U.S. GEOLOGICAL SURVEY
 Water Resources Division
 102 East Main Street, 4th Floor
 Urbana, Illinois 61801

This letter is in response to your July 1, 1994 letter reviewing the "Hydrologic Analysis of Ebner Coulee at LaCrosse, Wisconsin" that was submitted to Gary Lepak of Wisconsin Department of Natural Resources (WDNR) by the U.S. Geological Survey (USGS) on April 1, 1994. Pages 1 and 2 of your letter indicate that redoing the hydrologic analysis of Ebner Coulee is beyond the scope of the study originally recommended to the Federal Emergency Management Agency (FEMA) by WDNR. Complete details of the WDNR proposal to FEMA were not available to the Illinois District of the USGS. Therefore, the project proposal prepared by the Illinois District of the USGS to FEMA indicated that a review of the hydrologic procedures applied in the original Flood Insurance Study was needed for several reasons (discussed in detail below). Because FEMA did not contend this issue, the new hydrologic analysis was done.

Comparison of one-percent exceedance-probability flood computed with TR55 and the Clark unit hydrograph method in the original Flood Insurance Study (FIS)

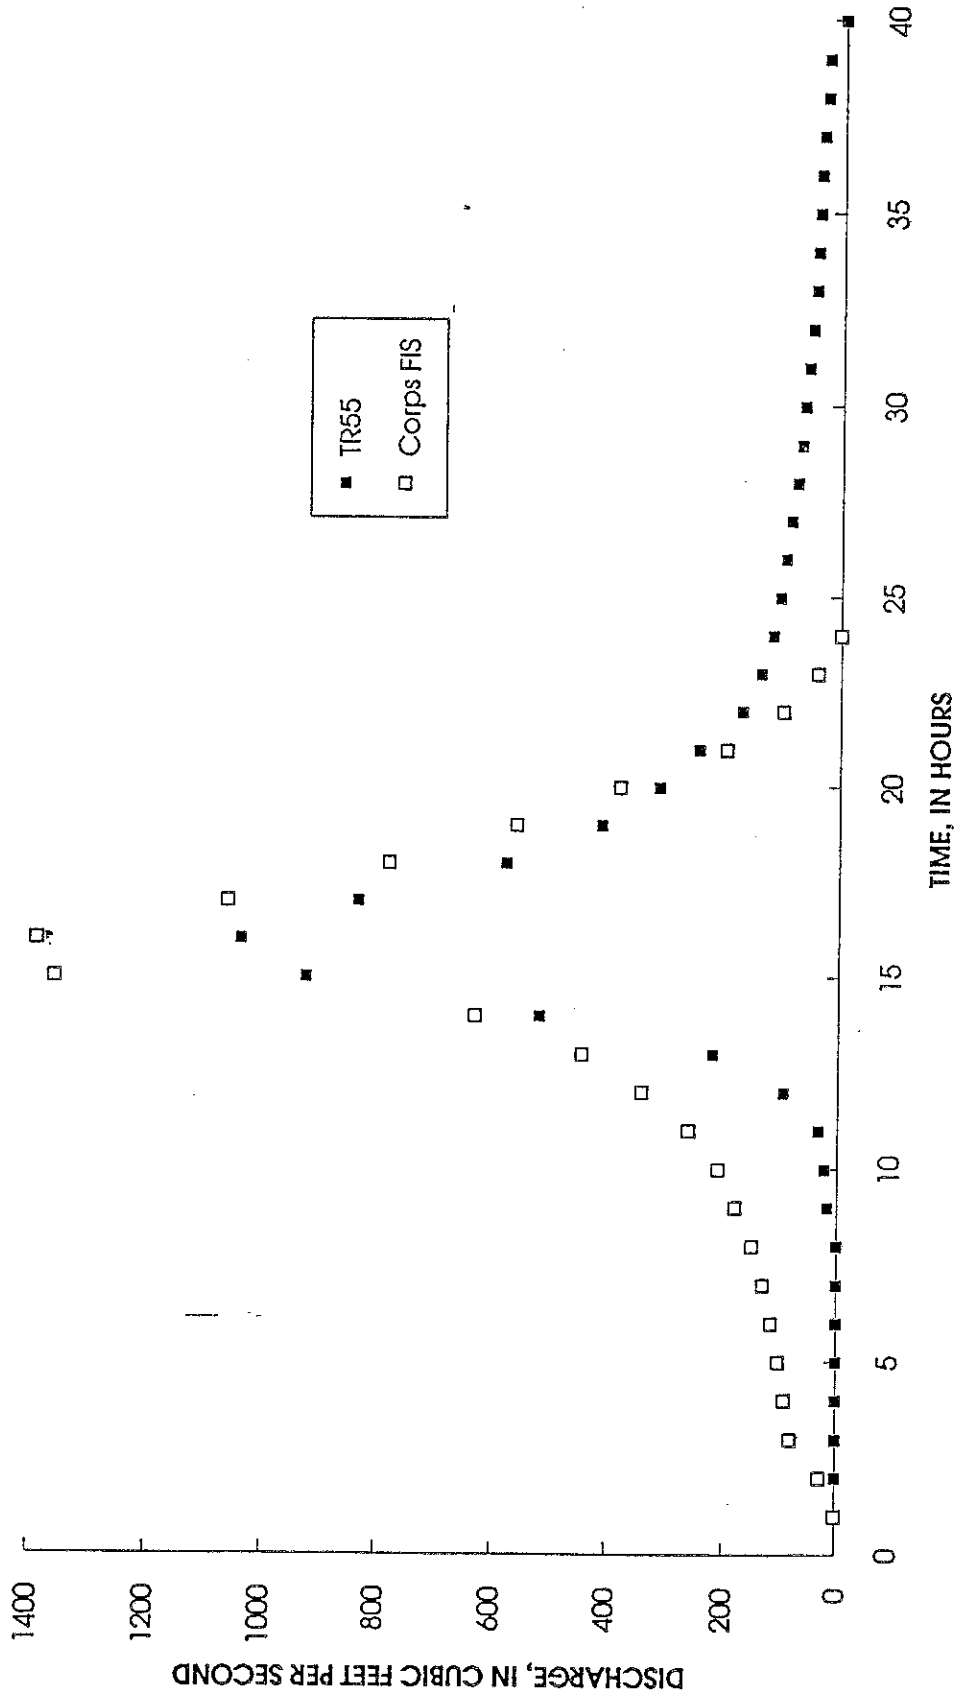
The point is well taken on page 2 of your letter regarding the volume of runoff being at least as important if not more important than the peak discharge. However, three factors should be considered. First, computation of the volume of direct runoff is highly dependent on the loss rates applied, which are not reported in the original Flood Insurance Study. Second, because the synthetic hydrograph methods applied are based on the Unit Hydrograph the volume of direct runoff is directly proportional to the magnitude of the peak discharge if the shapes of the design hydrographs are similar. Thus, if the peak discharge decreased 40 percent, the volume of direct runoff would also decrease 40 percent. The attached figure compares the one-percent exceedance-probability flood computed with TR55 and that determined in the original Flood Insurance Study (the TR55 result was shifted 7 hours so that the peak times of the two hydrographs are similar). It can be seen that the peak regions of the hydrographs are similar but the rising and recession limbs of the hydrographs are significantly different. Despite these differences in shape, the ratio of the depth of direct runoff 3.40 in./2.48 in. = 1.37 is similar to the ratio of the peak discharges 1,430 ft³/s/1,030 ft³/s = 1.39. Third, the volume of spill is also related to the amount of time that the runoff rate exceeds the capacity of leveed Ebner Coulee channel. Computation of spill for a flatter, more attenuated hydrograph, such as estimated in TR55, would result in more water remaining in the main channel of Ebner Coulee and less water spilling into the flood-prone neighborhoods upstream of the entrance to the box culvert.
